## Product Change Notice (PCN)

**PCN Number: PCN-0384612R-01**

Product(s) Affected: CMS-18138A-SP

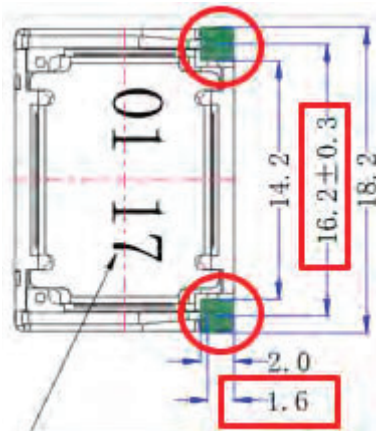
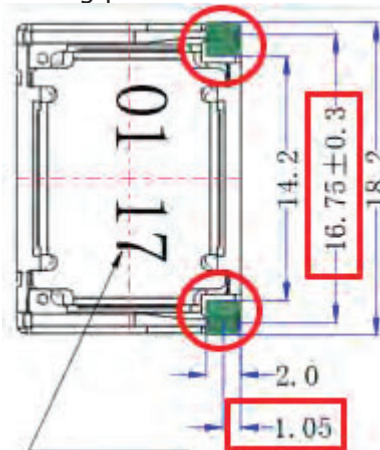
Reason(s) for Change: In altering the springs, we are able to meet more customer's applications.

Description of Change: Spring contacts replaced. PCB layout unchanged.

Pin Pitch-  $16.2 \pm 0.3$ mm  
 Touching point-  $1.6 \pm 0.2$ mm

Pin Pitch-  $16.75 \pm 0.3$ mm  
 Touching point-  $1.5 \pm 0.2$ mm

Additional Information: No change to fit or function. Form has been altered.
